To: Kristopher Byrd, Well Construction Manager
From: Tommy Laird, Well Construction Program Coordinator
Subject: Review of Water Right Application G-19169
Date: February 23, 2024

Application # G- 19169

TO: Water Rights Section Date 10/25/2023
 FROM: Groundwater Section Joe Kemper
Reviewer's Name
 SUBJECT: Application G- 19169 Supersedes review of NA
Date of Review(s)

Figure 2. Hydrograph of groundwater elevations from the Sisters area through the Deep Canyon area. DESC 2000 and DESC 1416 are 0.8 and 2.9 miles from the proposed POAs, respectively.

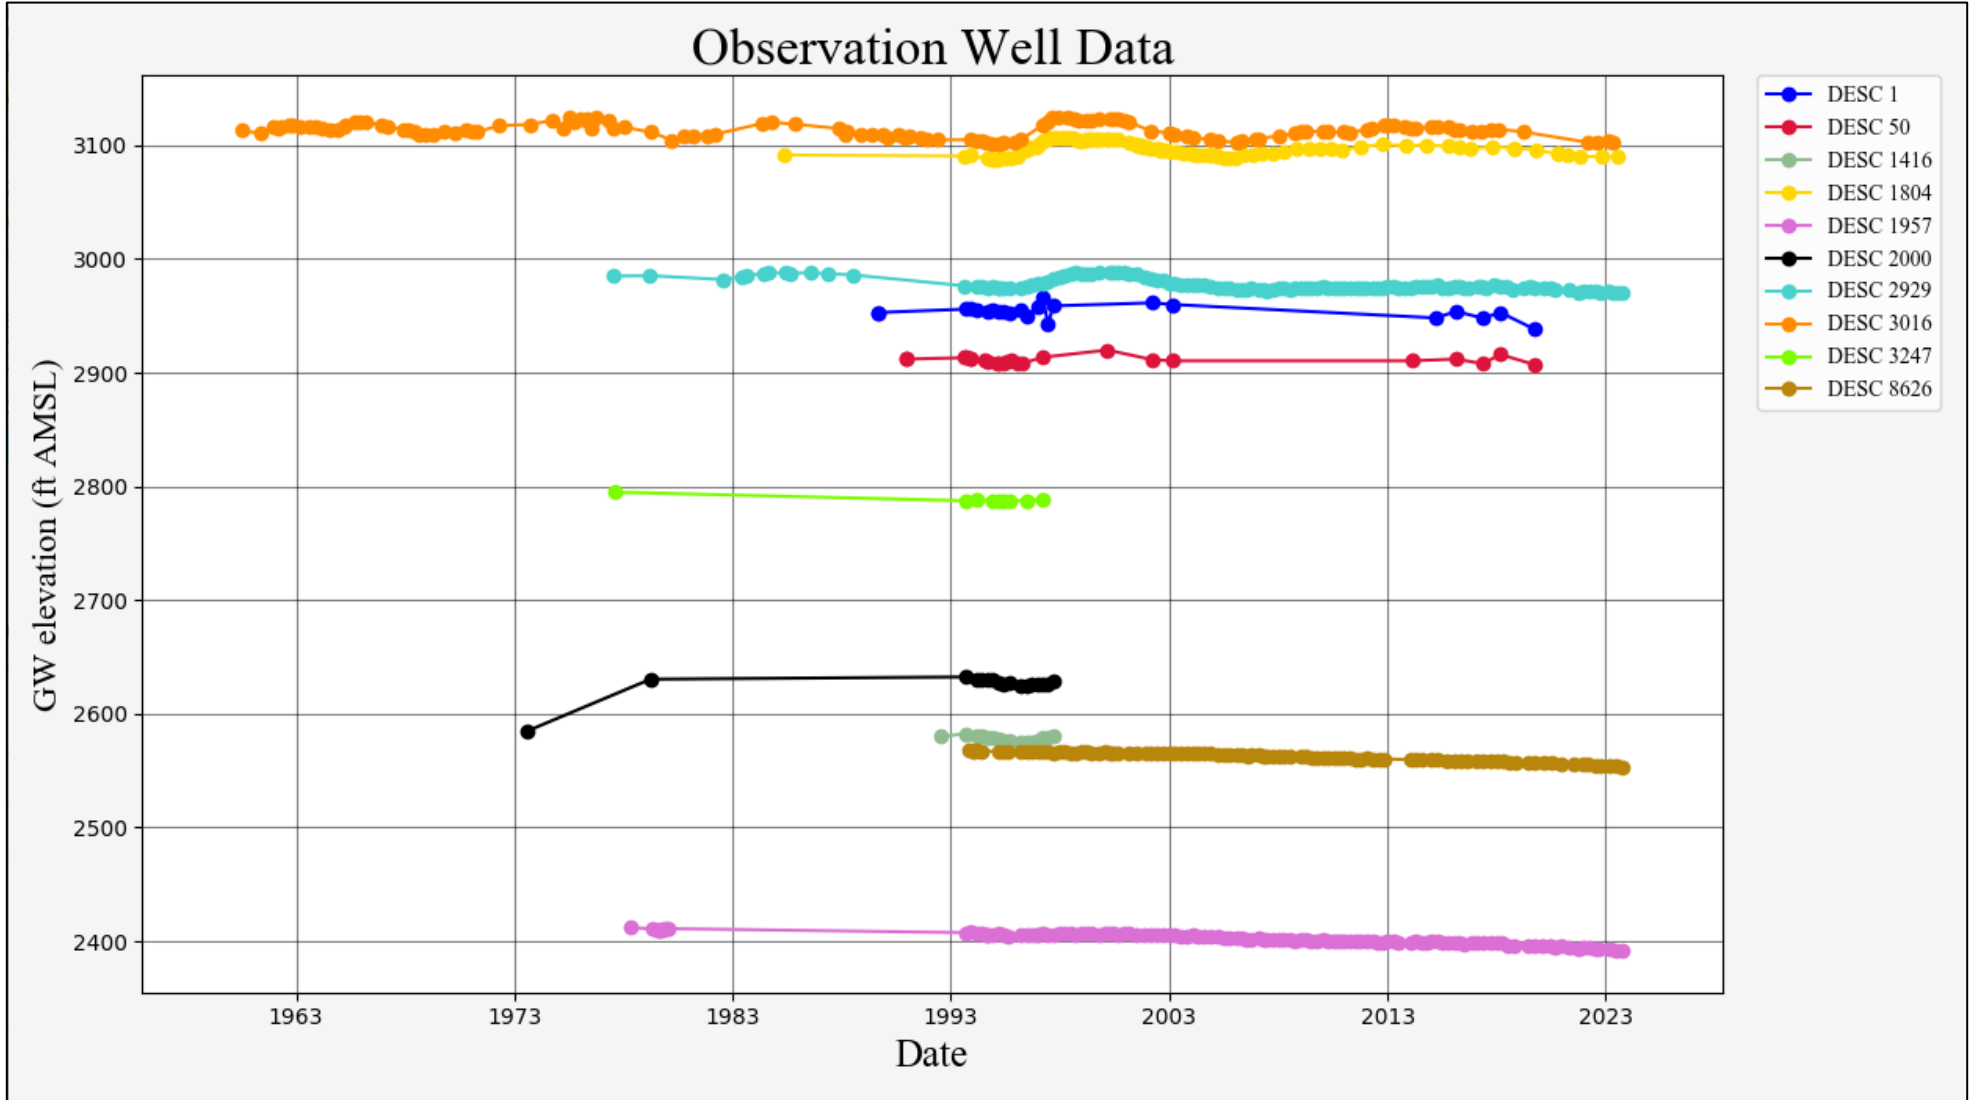
Several wells to the east of the proposed POAs (referred to as the “Deep Canyon Area” in Map 1) have shown persistent year-on-year declines totaling ~13 feet from 1994 to 2023 (see Figures 3 and 4). Studies by the USGS and OWRD have attributed these long-term declines to 1) long-term climate change, 2) groundwater pumping (see Figure 2), and 3) canal lining causing reduced recharge. The nearest well (DESC 1957) exhibiting this trend is approximately five miles to the east of the proposed POAs. Wells upgradient in the groundwater system from the city of Sisters (e.g. DESC 3016 and DESC 1804) show 10-20 feet of oscillation that tracks largely with decadal climate cycles. Current groundwater levels in those wells are at or near the same elevation as 1994. Just downgradient (NE) of Sisters, water levels in DESC 2929 rise 12-13 feet in response to the heavy precipitation of the late 1990s but respond very little to increased recharge in the early 2010s.

Current water levels are ~5 feet lower than in 1994. There are no long-term observation wells immediately adjacent to the proposed POAs that show water level trends there. Because the proposed POAs are located nearly equidistant between DESC 2929 and DESC 1957 in the same groundwater system, this review assumes that water levels at the application site show an intermediate of those two trends. Specifically, water levels have likely shown declines since approximately 2000 on the order of 5-10 feet.
